STANNAH LIFTS LTD – MRLi – HYDRAULIC PASSENGER LIFT

TECHNICAL BULLETIN**SAFETY ISSUE**

Subject : Replacement of down pilot valve (Ref "VMD")

Identification of VMD:

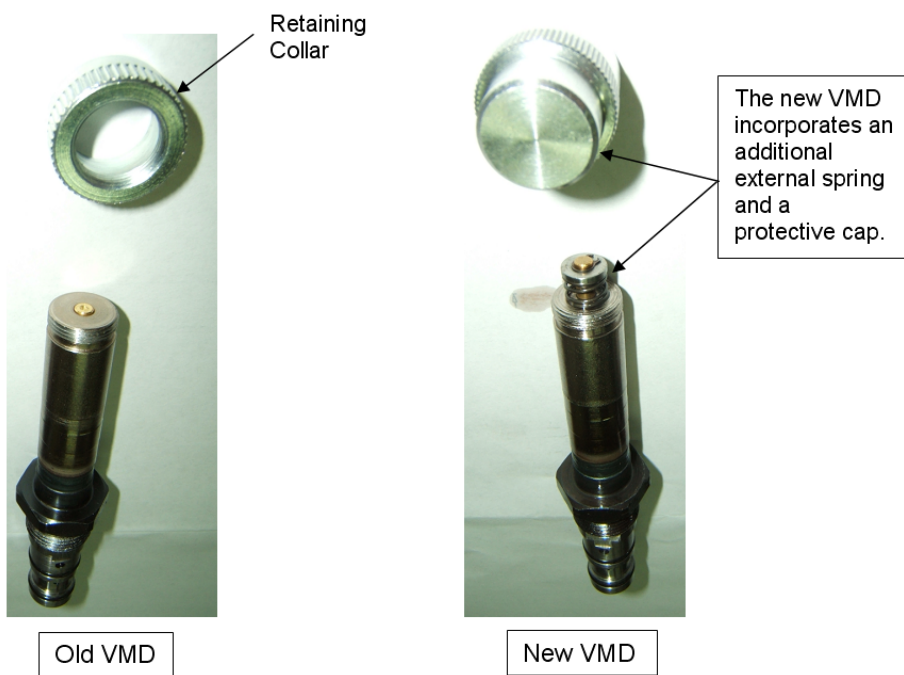
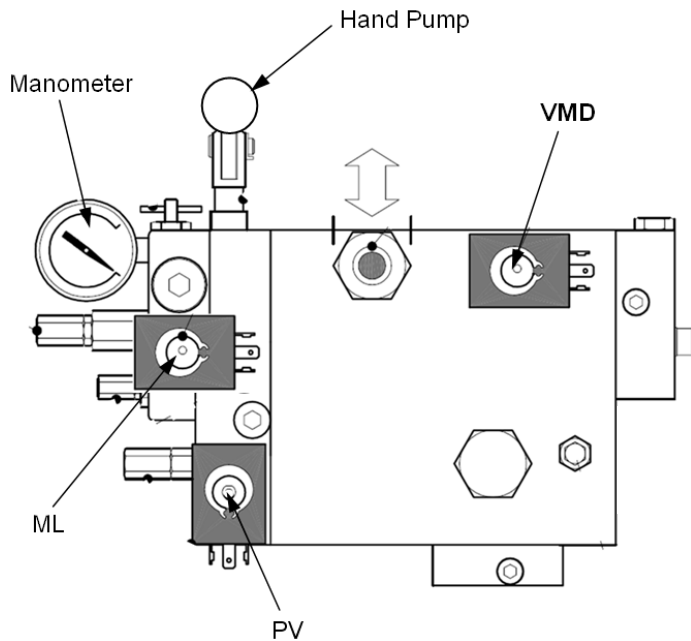
Subsequent inspection of valves has established that all valve failures to date have been of an older version of the down pilot valve (Ref "VMD"). In order to reduce the probability of any further valve failures, Stannah Lifts Ltd request that all older versions of VMD are replaced with the new version. The old version was present on all MRLi power units manufactured up until January 2008. Those MRLi power units already equipped with the latest version VMD do not require a valve change.

- All MRLi models with the old version VMD are to have the newer version VMD fitted before or at the next scheduled service interval.
- Continue to actively progress the action points of bulletin TB82 (fitting of pawl devices etc).
